**Re:** Proposed flood relief scheme  
in Mountmellick, County Laois

**Re:****Mountmellick Flood Relief Scheme – Observation under:**

The below-signed residents of Derrycloney, Mountmellick (Residents) are making this observation in relation to the proposed Mountmellick Flood Relief Scheme (FRS), particularly its impacts on properties in the Derrycloney area located on the high bank of the river.

Figure 1: Original Modelled Flood Plain in Scenario 1 with Derrycloney boxed for clarity, from:  
 - "19105-JBAI-XX-XX-RP-B-00314\_Appropriate\_Assessment\_Screening\_C01\_0.pdf"  
 - "19105-JBAI-XX-XX-RP-B-06129\_NIS\_C02.pdf"

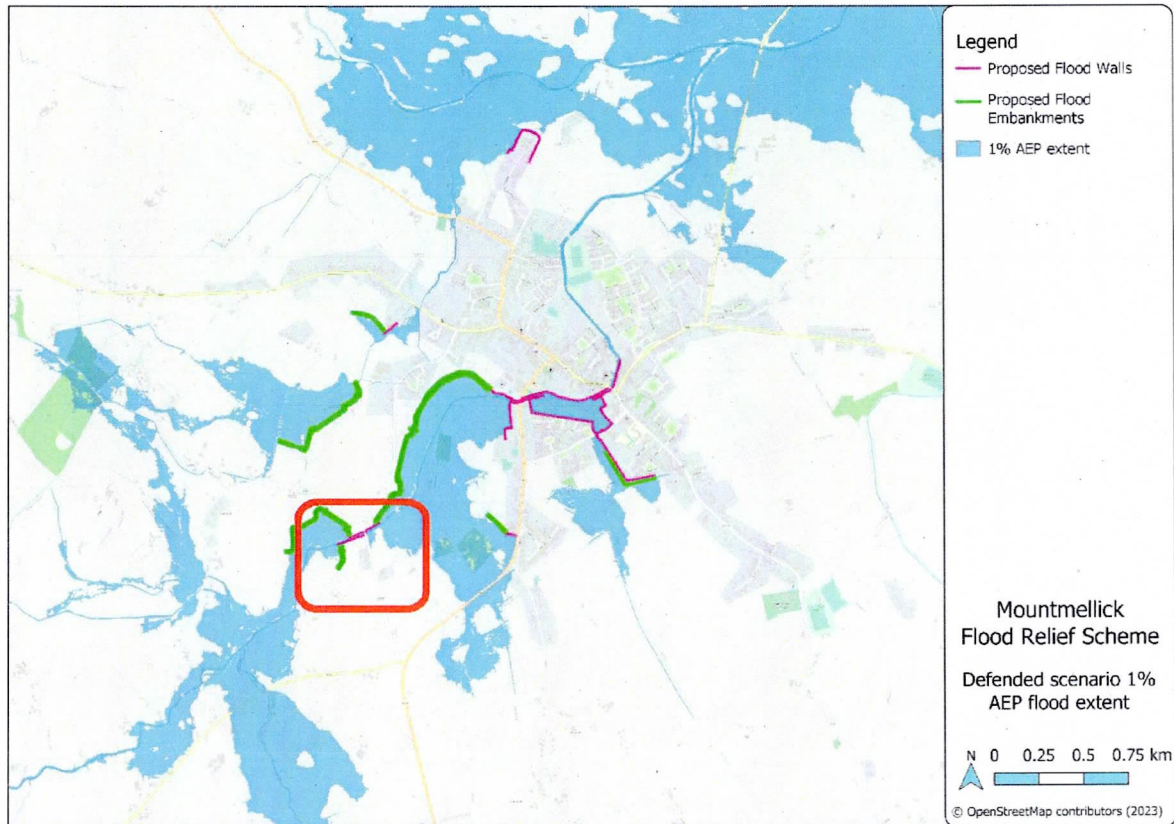
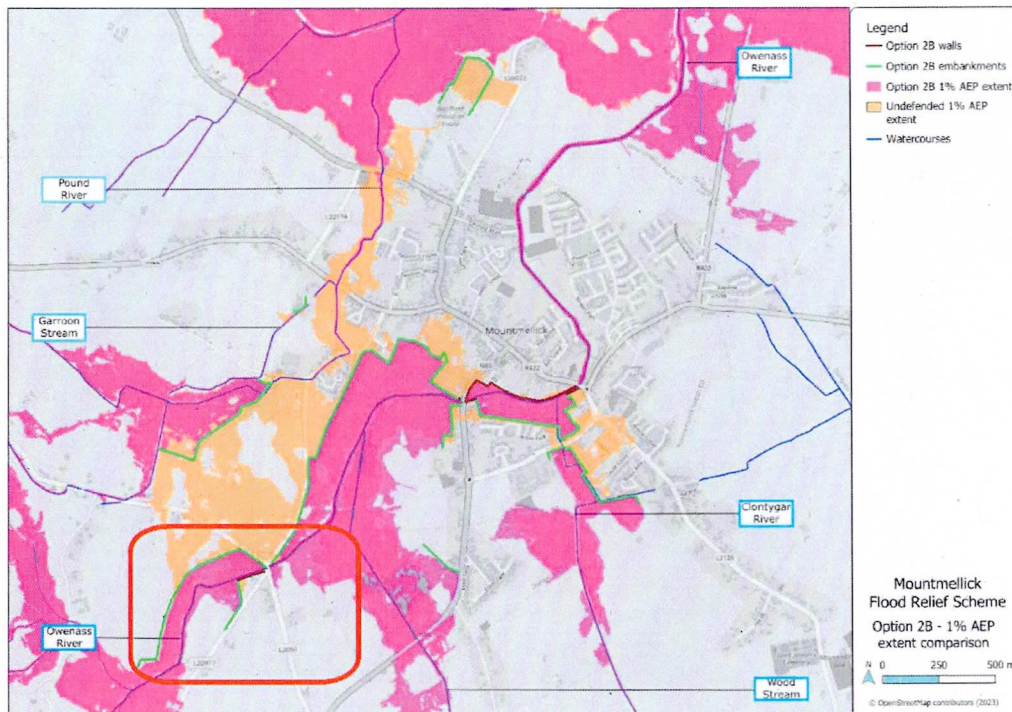
- The documents made available as part of this planning application still show the original flood map, even though both the residents and the consultants accept that this mapping underestimates flooding in Derrycloney. This is reflected in updated flood maps shared with Derrycloney Residents on 7 August 2025, belatedly responding to a request from Derrycloney Residents for updated information issued on 20 April 2024.
- This is likely to mislead the public and decision-makers regarding:
  - The true extent of flood risk in the area,
  - The true extent to which the FRS may increase risk to the high bank houses.

For a project of this scale and sensitivity, accurate and up-to-date modelling and mapping are fundamental to both the planning process and the Environmental Impact Assessment (if applicable). Using known-to-be-outdated maps in the public documentation is not consistent with best practice, nor with transparent and informed public participation.

1. Require updated and complete hydraulic modelling and mapping to be submitted as part of the application, reflecting:
  - o The latest agreed model for Derrycloney,

- o Flood extents and depths for all six scenarios, with and without the FRS, clearly showing differences for both low bank and high bank properties.
2. Require the scheme promoters to demonstrate, with this updated modelling, that the FRS will not materially increase flood levels or risk to the high bank houses for at least:

- o Extension of the public water network to provide a safe, reliable alternative to private wells in at-risk areas.
  4. Require that all public planning and environmental documentation be updated to remove outdated flood mapping and include the most recent, agreed modelling outputs, to ensure transparency and proper public participation.

Figure 4: Updated Flood Plain in Scenarios 1, 2 and 3.

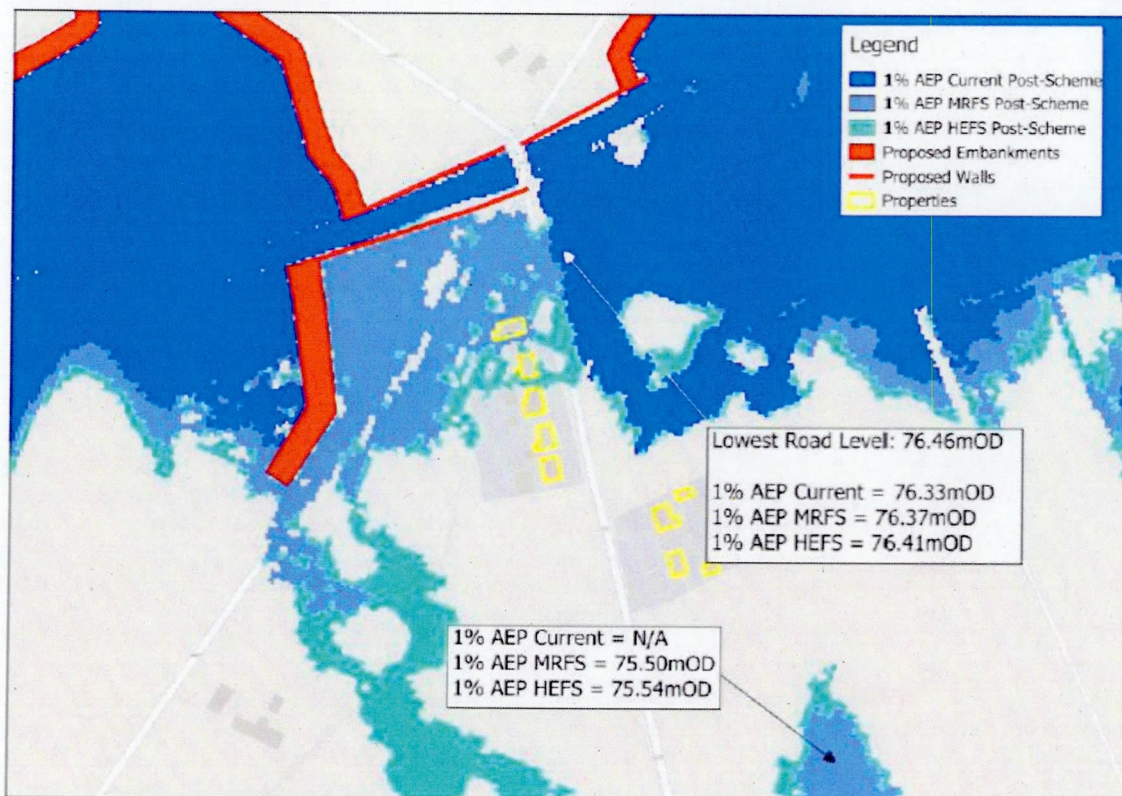
The modelling indicates that at some point between scenario 1 (1% AEP) and scenario 2 (MRFS), at least one well and one septic tank at the high bank houses will be topped by floodwater. Given the connectivity of groundwater in this area, neighbouring wells draw from the same or connected aquifers and are therefore also at risk.

- They identified problems with the original flood model in the local Derrycloney area.
- Consultants subsequently updated the analysis, which showed additional flooding in Derrycloney compared with the original model.
- Residents have further pointed out that even this updated model remains incomplete and does not fully capture the risk.
